**City of Ketchum
Planning & Building**

IN RE:)
)
The Perry Building) KETCHUM PLANNING AND ZONING COMMISSION
Design Review) FINDINGS OF FACT, CONCLUSIONS OF LAW, AND
Application File Number: P22-045C) DECISION
)
)
Date: March 28, 2023)

PROJECT: The Perry Building

APPLICATION TYPE: Design Review

SITE PHOTOMETRICS GROUND PLANE

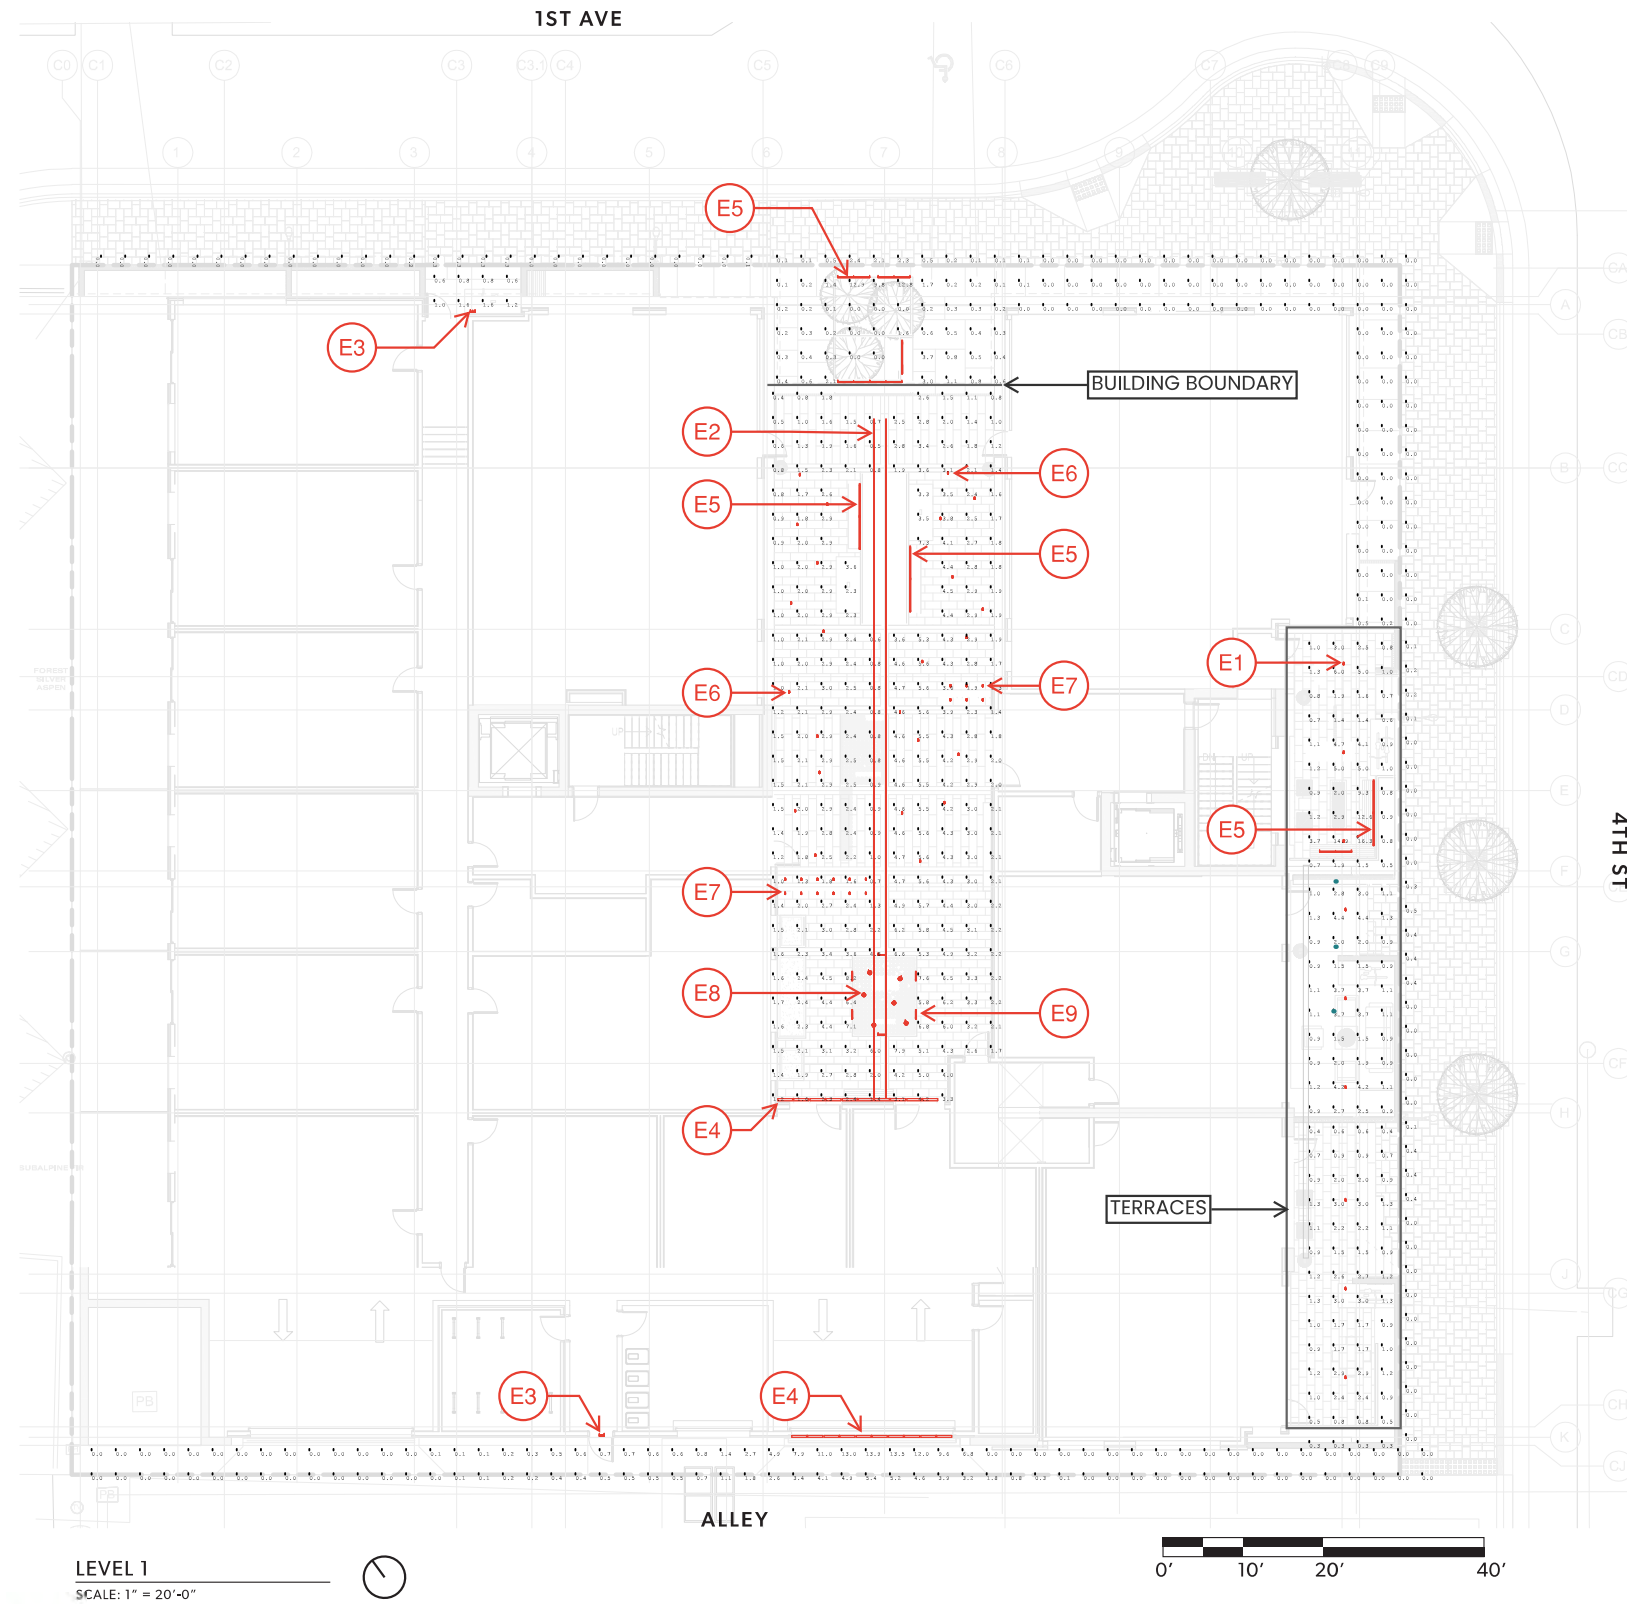
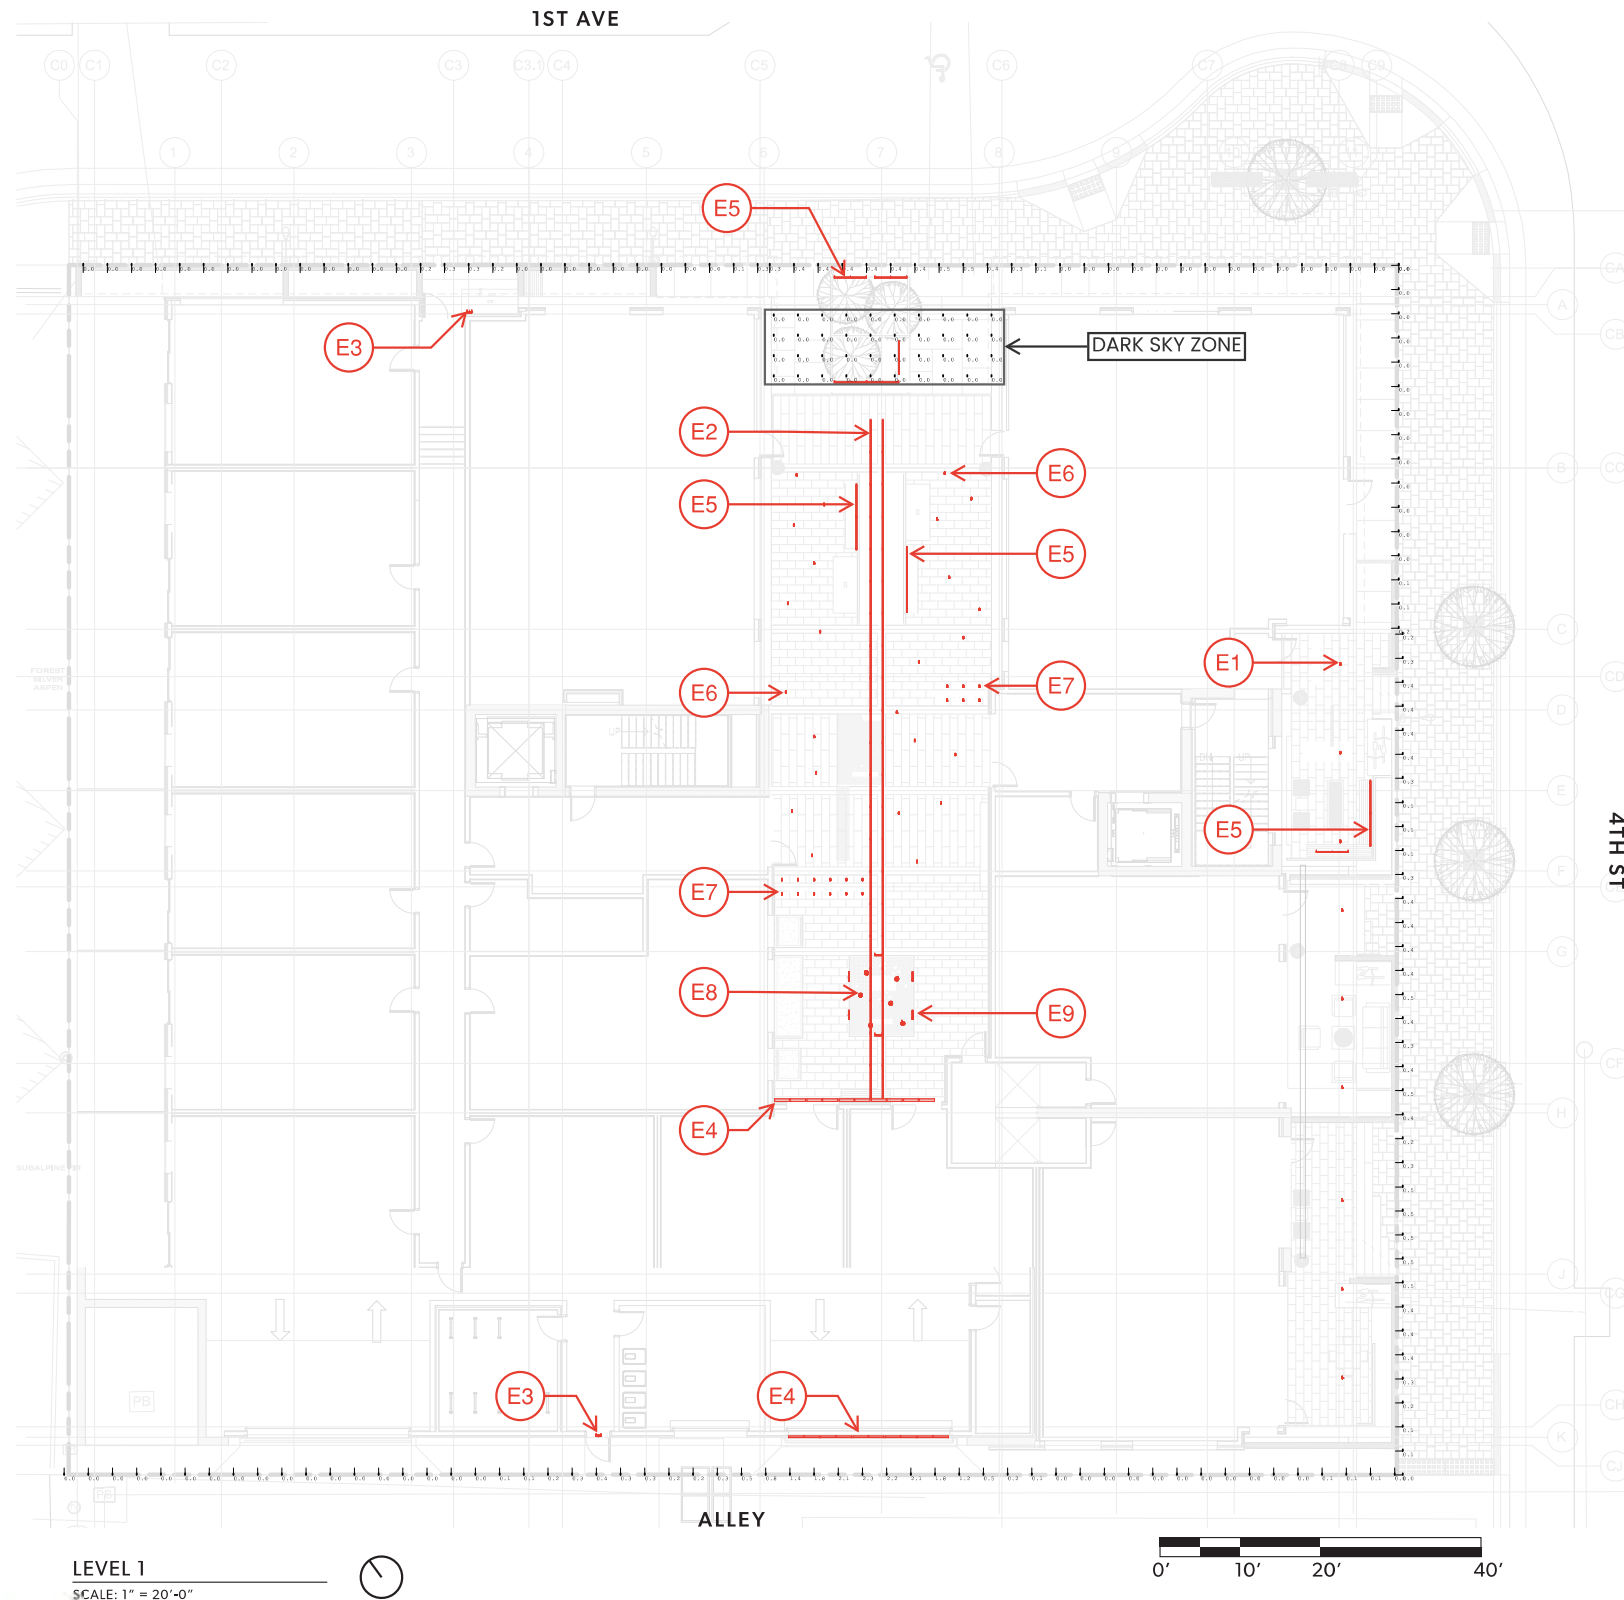
The applicant has provided two site photometric studies on pages 53 and 54 of the project plans. The photometric study on page 53 measures the light levels at the ground plane. The photometric study on page 54 measures the light levels 60 inches above the ground plane. Pursuant to KMC §17.132.030.B1, “all lighting emitting from any zoning lot shall not cause the light level along any property line, as measured at a height of 60 inches above grade in a plane at any angle of inclination, to exceed the limitations listed in figure 1, ‘Light Trespass and Overlighting Matrix,’ of this subsection.” The light trespass and overlighting matrix does not provide maximum foot-candle limits for light trespass in the Community Core.

The recessed garage door lighting illuminates the parking garage entrance up to 2.3 footcandles at the alley property line. The Commission and Staff are concerned that this fixture may cause glare along the alley. In order to both protect against direct glare while providing safe lighting for the garage entrance, the Commission determined that the garage door lighting should comply with the city’s right-of-way lighting standards. Pursuant to condition #3, the applicant shall revise the garage door lighting and submit an updated photometric study that shows an average of 0.2 footcandles at the rear property line for Planning staff to verify that the fixture does cause glare along the alley prior to issuance of building permit.

ROOF OVERHANGS

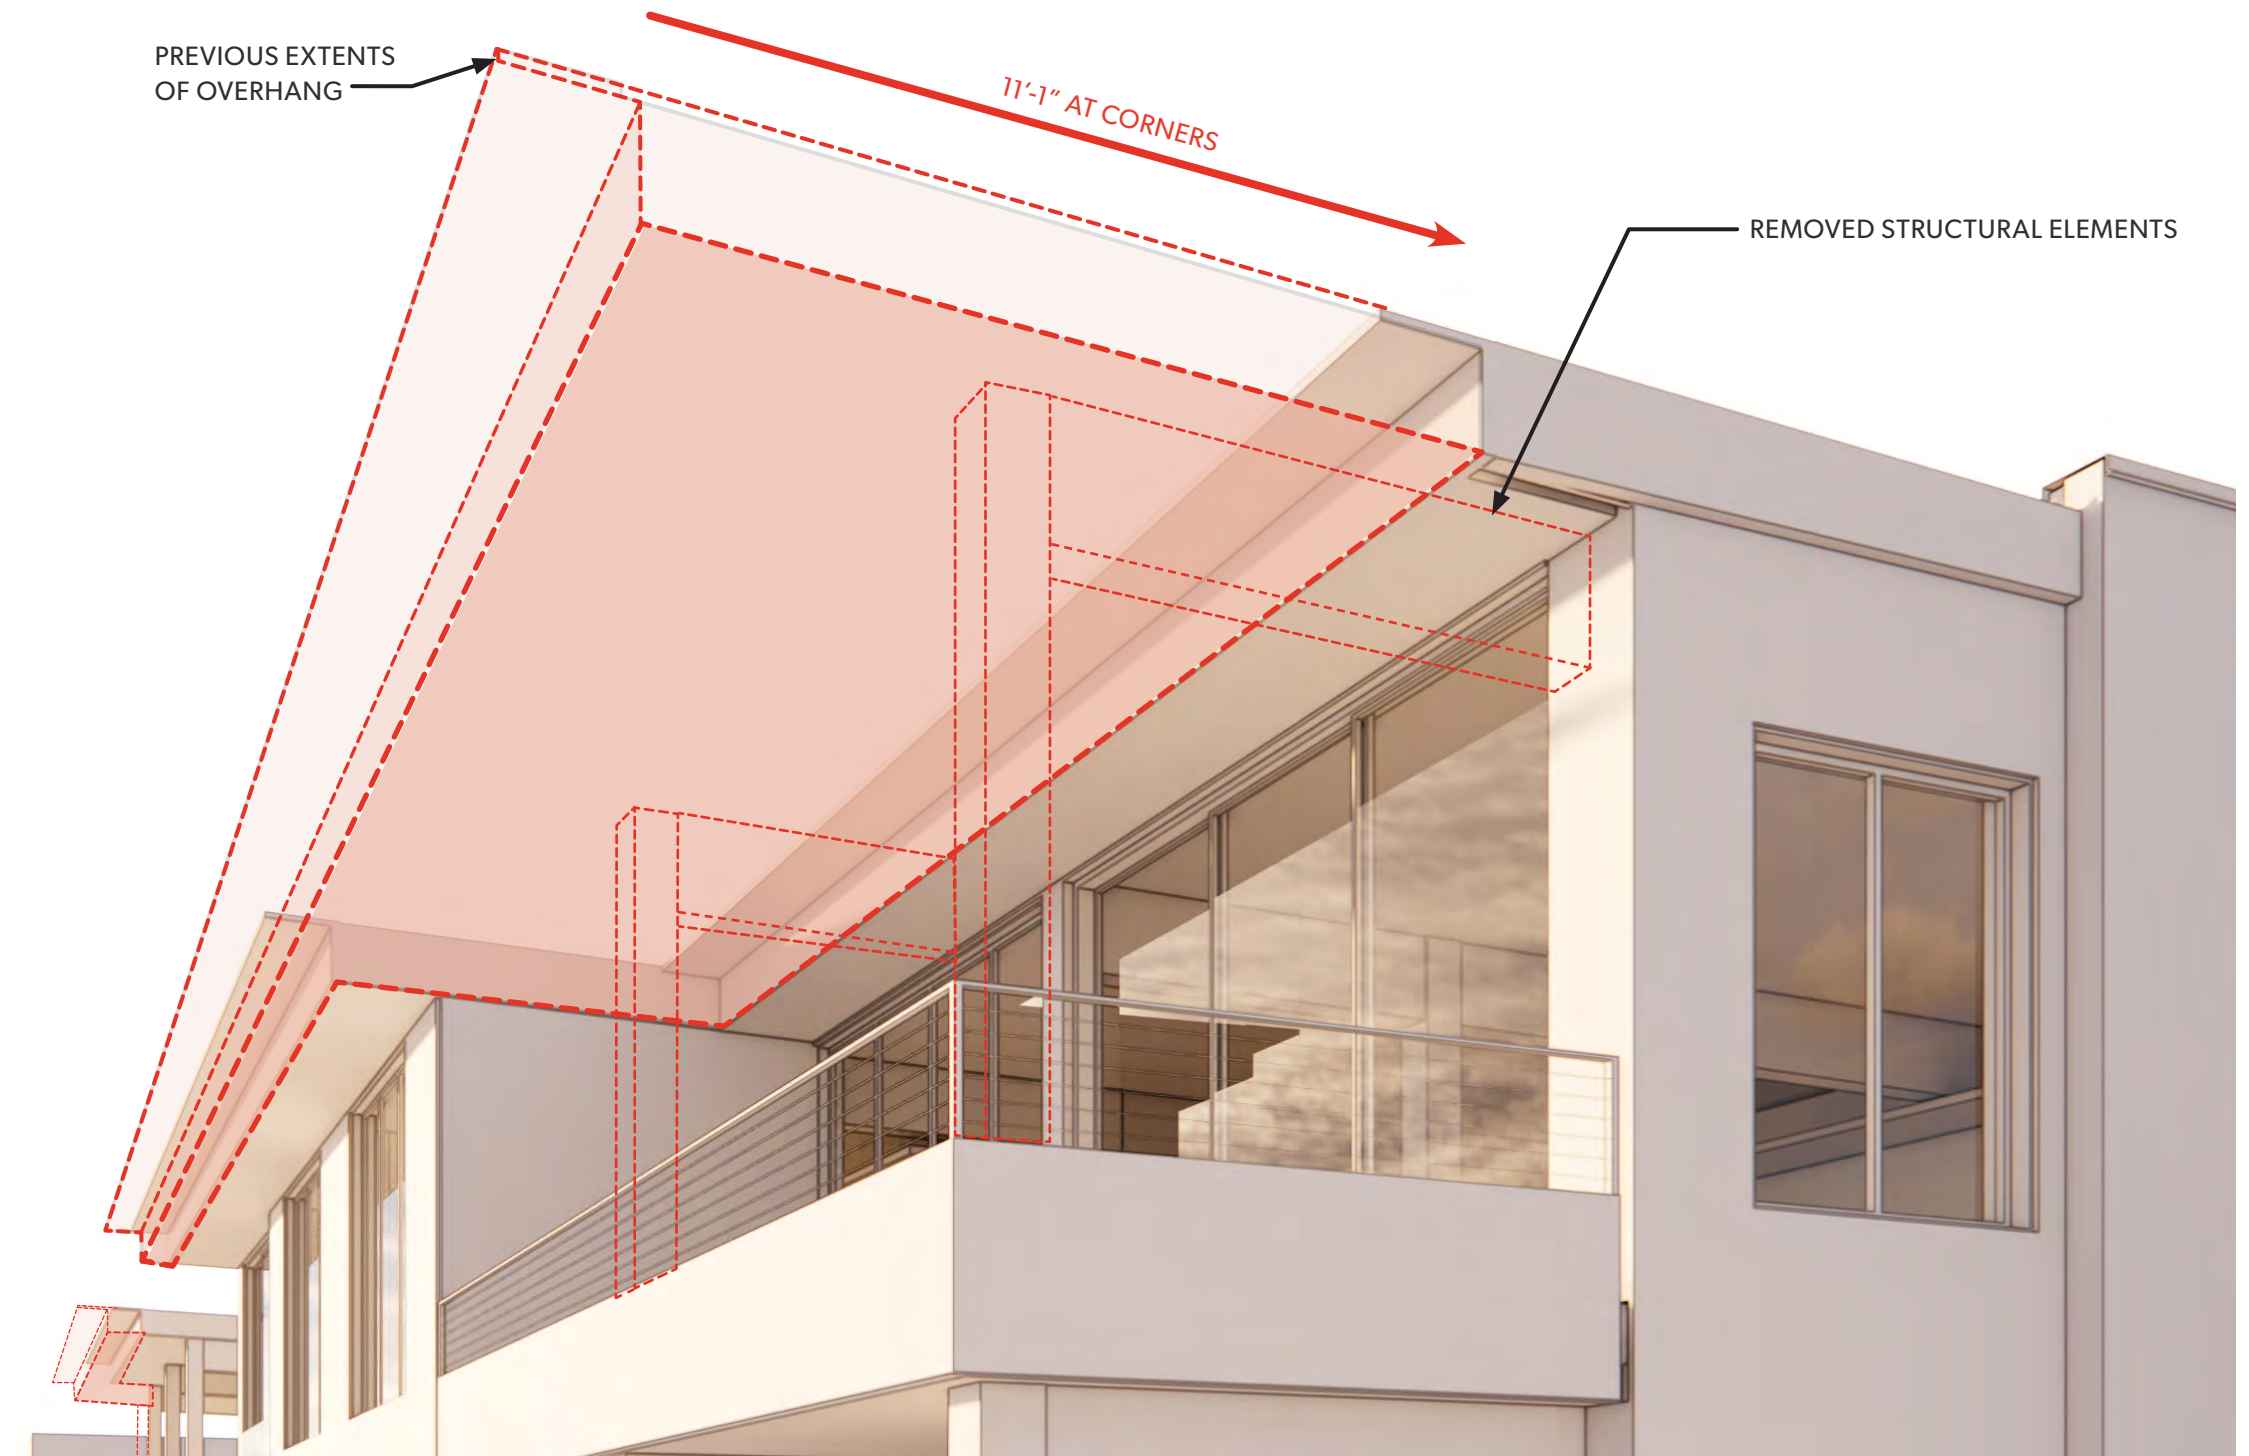
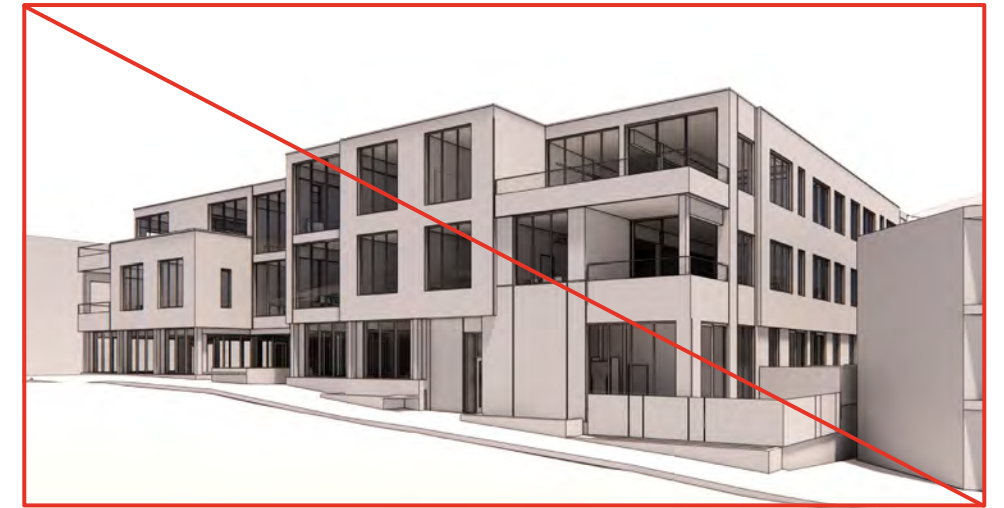
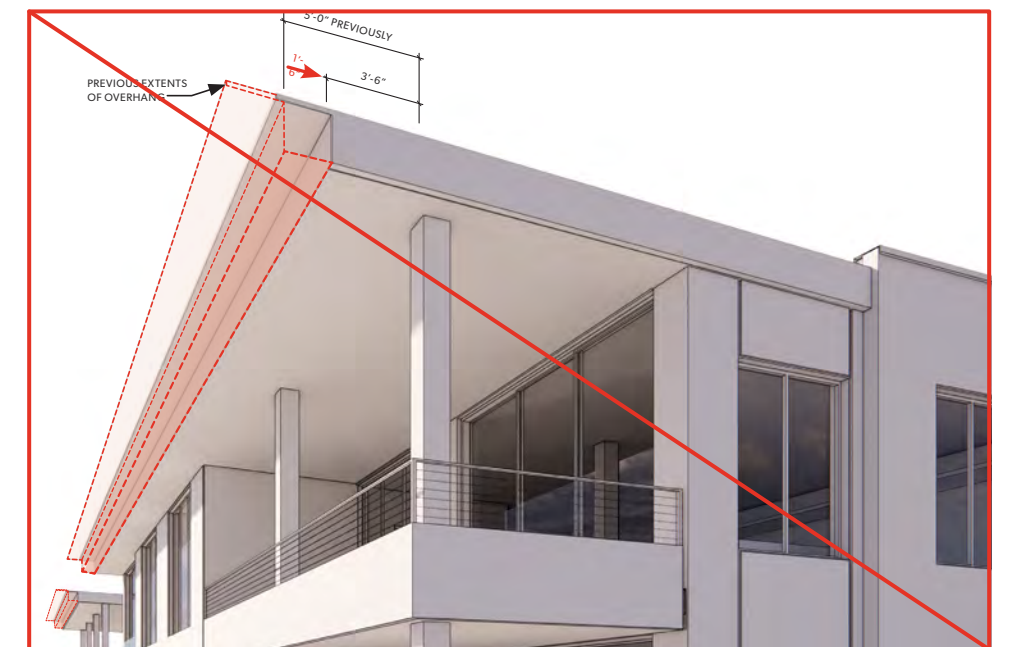
During their review of the Pre-Application, the Commission commented that the uniform roof plane along 1st Avenue diminished the effectiveness of the carve in building mass created by the courtyard. The Commission recommended that the applicant vary the design and height of the roof plane along 1st Avenue. The applicant’s response to this comment is provided on pages 65 and 68 of the project plans. The applicant states:

The removal of the projecting overhangs along 1st Avenue adds variety to roof-plane heights and emphasizes the recessions in building mass at the upper-level balconies. Aligning the roof form with these recessions reduces the perceived height and mass of the building.

We explored providing various roof forms along 1st Avenue and integrating a flat roof. This results in a less effective form by breaking up the overhang and loses cohesion of the overall composition along this frontage.

We explored an option in which we removed the overhang along 1st Avenue in its entirety. This poorly responds to the climate by not providing covered outdoor space and results in more modernist rectilinear forms that do not respond to the community context.
